MARSTON

PLANNING CONSULTANCY

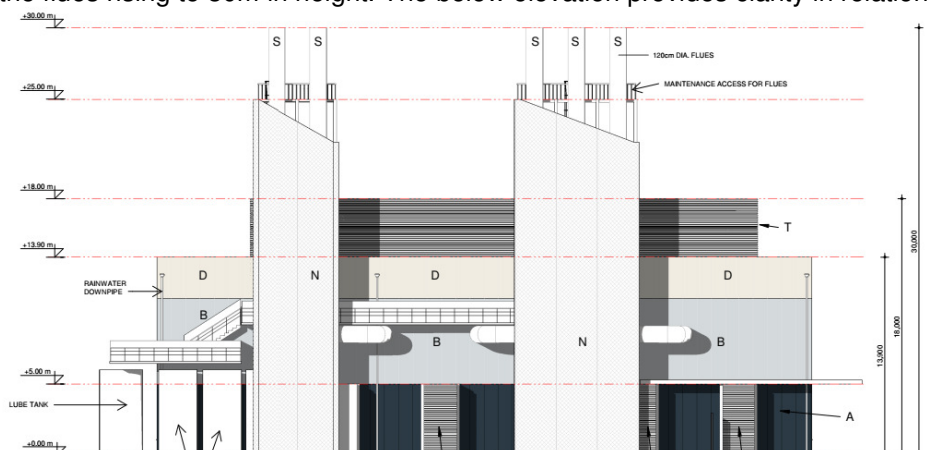
We note the clarifications sought by the Planning Authority in relation to what was referred to as the Permanent power plant under the originally submitted application, and is now referred to as the Multi-Fuel Generation Plant under this AI response. Its redesign required it to be remodelled from a noise and air quality perspective. Their original height of 25m, due to their repositioning were resulting in them negatively impacting the cooling capabilities of the chillers on the roof of the data centers that would require more energy to cool the facility, which is a key component of the workings of a data centre.
